Report on Assumptions in Duke Energy May 2022 Carbon Plan,
William E. Powers

Report on Assumptions Used in Duke Energy May 2022 Carbon Plan

Bill Powers, P.E., July 15, 2022

Figure 4. Natural gas price projection in the Carbon Plan³⁵

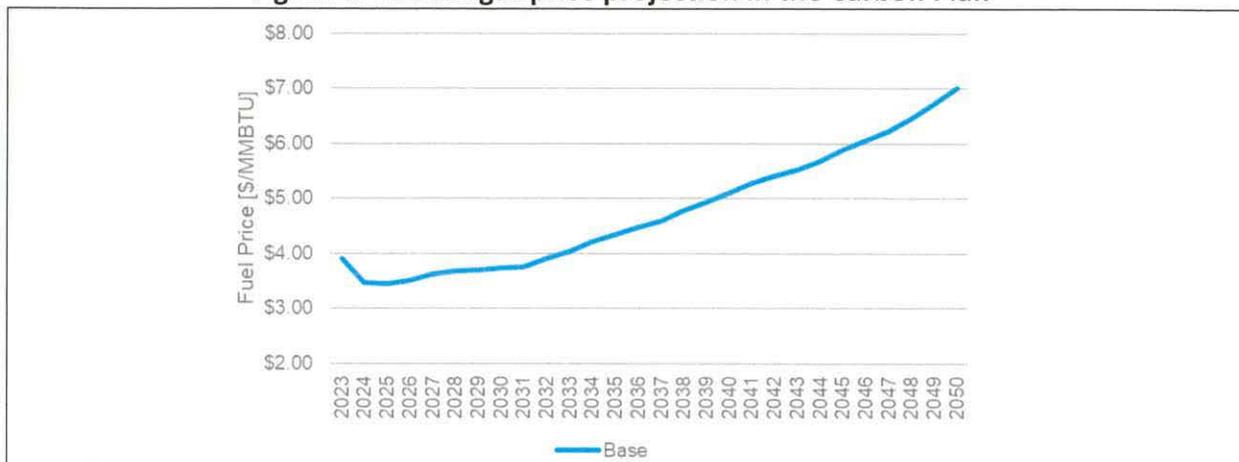
Natural gas price volatility has been an inherent feature of the natural gas market, as shown in Figure 3. Natural gas prices have been especially volatile in 2022, with the May 2022 Henry Hub price over \$8 per million Btu. Western Europe has become a high demand, priority delivery point for U.S. natural gas in the form of LNG in the wake of the Ukraine war, driving increases in U.S. natural gas prices. Yet the Carbon Plan assumes a low base price for natural gas, under \$4/MMBtu through 2032 rising to \$5/MMBtu in 2040, as shown in Figure 4.

The price of natural gas is volatile over time, as shown in Figure 1. In contrast, there is no price volatility over time in the price (free) or availability of solar power.

Figure 5. Relationship of battery capacity to ELCC value for the solar plus battery case⁶⁸

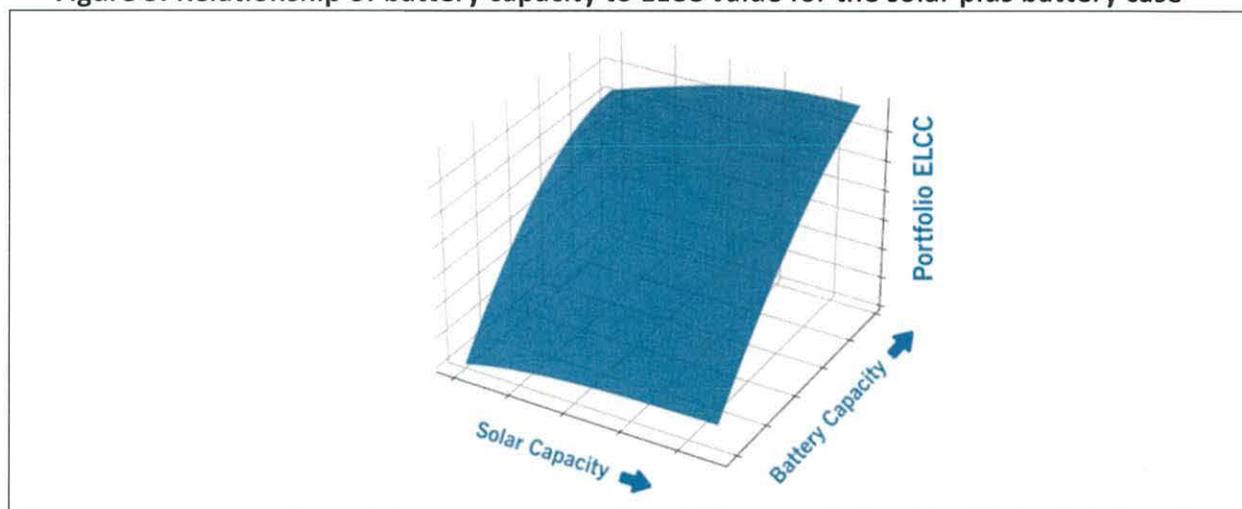
This result is achieved by assuming the solar with battery storage alternative only has about one hour of battery storage in the Electric Load Carrying Capacity (ELCC) analysis, and by assuming winter peak conditions when little solar power is available. The ELCC is the "capacity value of a resource and can be thought of as a measure of the reliable capacity contribution of a resource being added to an existing generation portfolio."⁶⁷ The more battery storage that is added to the solar resource, the higher the ELCC value, as shown in Figure 5.

The utility-scale solar plus battery building block in the Carbon Plan ELCC analysis is a 75 MW solar array coupled to 20 MW of battery storage with 80 MWh of storage capacity.⁶⁹ This is approximately one hour of storage at the solar array design capacity of 75 MW.⁷⁰ Not surprisingly, this inadequate amount of storage results in the solar plus storage alternative having a low ELCC.⁷¹

The Companies ELCC modeling indicates that as more-and-more battery storage capacity is added, longer-and-longer battery durations are needed to maintain high ELCC values. That is what should be modeled. What should not be modeled is a single solar plus battery storage profile with a badly undersized battery storage component. The predictable result is that solar plus battery storage will provide little contribution to reliable capacity, and therefore must be supplemented with other resources like CTs.

Recommendation: The Companies should model three new solar plus storage profiles, solar plus 4-hour storage, solar plus 6-hour storage, and solar plus 8-hour storage, and provide the ELCCs for those profiles in a revised Carbon Plan.

Figure 7. Modified Scenario 9 with an increase of storage capacity to 65,000 MWh
(all solar power that would otherwise be curtailed is directed to storage)

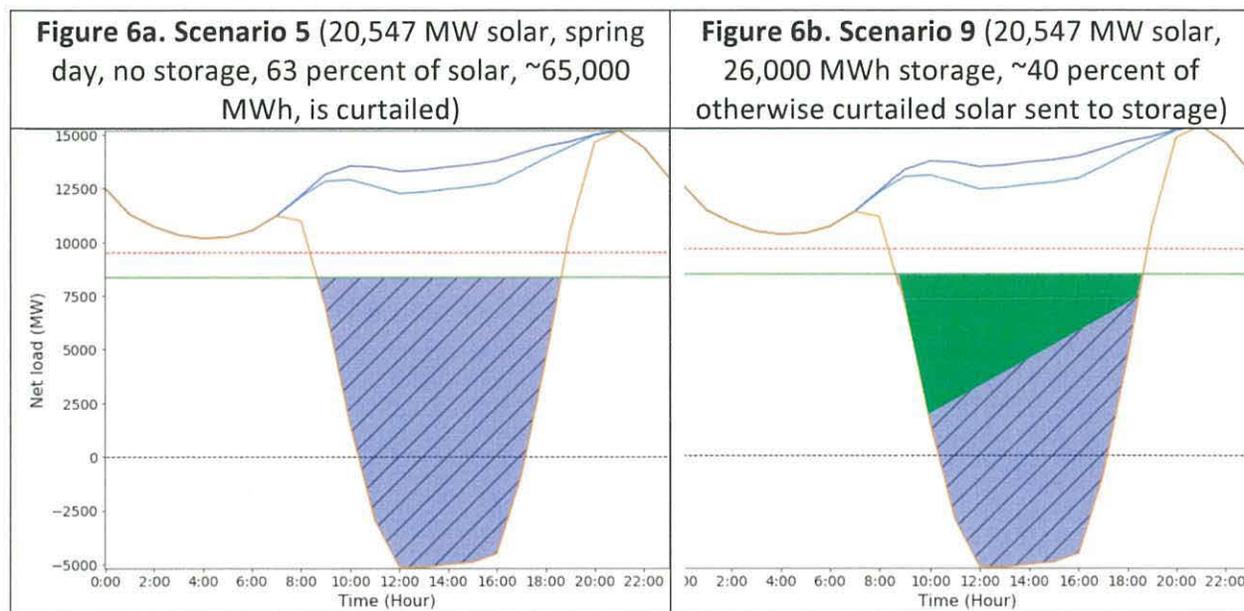
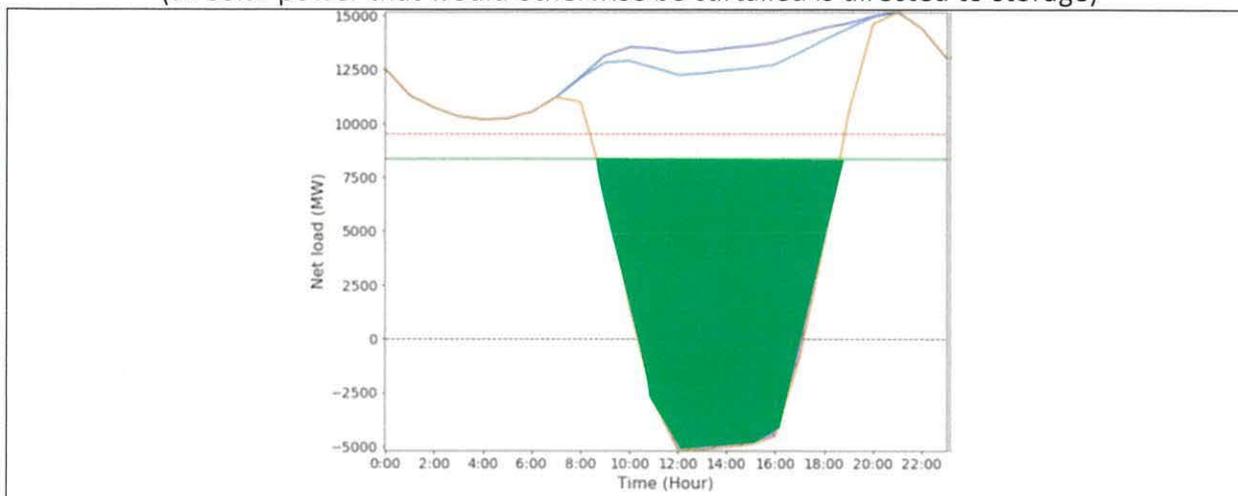
Scenario 9 misstates the ability of storage to fully absorb the excess solar generation by including far too little storage in the scenario. Scenario 9 matches 20,547 MW of solar capacity with 26,000 MWh of storage.⁷⁷ This equates to about one-and-a-quarter (1.25) hours of storage per MW of solar capacity.⁷⁸ This is similar to the ratio in the scenario that the Companies adopt in the Carbon Plan: 75 MW of solar capacity is combined with 80 MWh of battery storage. This equals 1.07 hours of storage per MW of solar capacity⁷⁹

In spring and fall, solar will produce 4 to 5 MWh per day per MW of capacity.⁸⁰ In the case of Scenario 9, the 20,547 MW of solar capacity will produce 80,000 to 100,000 MWh of solar power per day, but there is only 26,000 MWh of storage capacity to absorb this solar output. This means that, solely due to underspecifying the amount of battery storage in Scenario 9, there will be a substantial amount of solar curtailment.

This is shown in Figure 6. The NREL study estimates that on a spring day, with 20,547 MW of installed solar capacity and no additional storage, about 63 percent of that spring day solar

production – about 65,000 MWh⁸¹ – would have to be curtailed, as shown in Figure 6a. If 26,000 MWh of storage is added, consistent with Scenario 9, 40 percent of this 65,000 MWh of solar power would be directed to storage, while the other 60 percent would be curtailed. This is shown in Figure 6b, where 40 percent of the otherwise curtailed solar power is directed to storage (green fill).

What is missing from the 2020 NREL study, and from the Companies’ Carbon Plan, is the scenario (or scenarios) that increases battery storage capacity sufficiently to eliminate, or nearly eliminate, solar power curtailments under light load spring and fall day conditions and to maintain the solar plus storage ELCC at or near 100 percent. For example, if Scenario 9 were modified to increase the amount of storage to 65,000 MWh, then the amount of solar curtailment in Scenario 9 would be reduced to zero as shown in Figure 7.

This 2020 NREL study should not be relied upon by the Companies or the NCUC as a justification for rejecting SPS as the centerpiece of a carbon-neutral strategy for the Companies in North Carolina. The single solar and storage scenario analyzed by NREL (Scenario 9) leaves the mistaken impression that above some moderate threshold, with or without storage, much of the produced solar power will go to waste (curtailment). The Companies present this same erroneous information in the Carbon Plan as if it were a fundamental characteristic of the solar plus battery storage alternative.

This result is exclusively an artifact of the limitations placed on the solar plus storage scenario studied by NREL in 2020 and in the Carbon Plan in 2022, and not an inherent characteristic of a proper balancing of solar and storage resources. When the storage capacity is properly sized to the solar capacity, as shown in Figure 7, all of the solar capacity can be put to productive and reliable use, including on spring and fall days with light demand. There is no inherent operational ceiling on the amount of solar capacity that, when matched with properly-sized storage capacity, can provide reliable capacity to meet the Companies demand and provide fully dispatchable power.

Figure 8. Comparison of Duke Energy actual demand growth to forecast demand growth¹⁴⁵

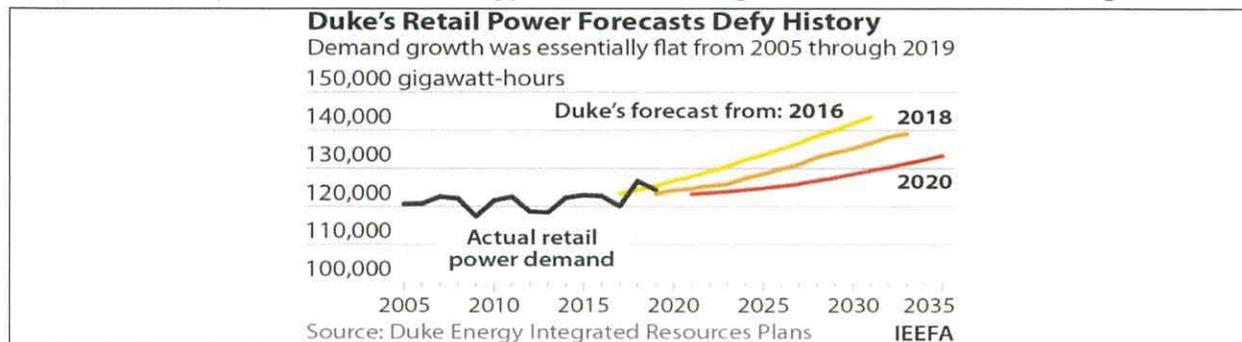
DEC and DEP have consistently overestimated demand growth in their respective service territories, as shown in Figure 8.

Actual DEC retail sales growth from 2016 through 2021, the most recent five-year period shown in the Carbon Plan, averaged 0.0 percent.¹⁴⁶ The Companies analyze the period 2012 to 2021 to assert a sales growth rate forecast for DEC of 0.8 percent.¹⁴⁷ 2012 was a relatively low retail sales year, as can be seen in Figure 8. Using 2012 as the base year gives the impression of significant demand growth over time, when review of the record going back to 2007 shows no growth. The Duke Energy retail sales growth rate forecast used in the Carbon Plan is not supported by actual historical DEC retail demand.

The last fifteen years of data on the Companies’ annual retail sales (Figure 8) and winter peak demand trends¹⁵⁶ provide no basis for projecting any annual energy demand or peak load growth going forward. Much of the CT and nuclear build-out proposed by the Companies in the 2035 to 2050 timeframe is designed to meet load growth that is highly unlikely to materialize.
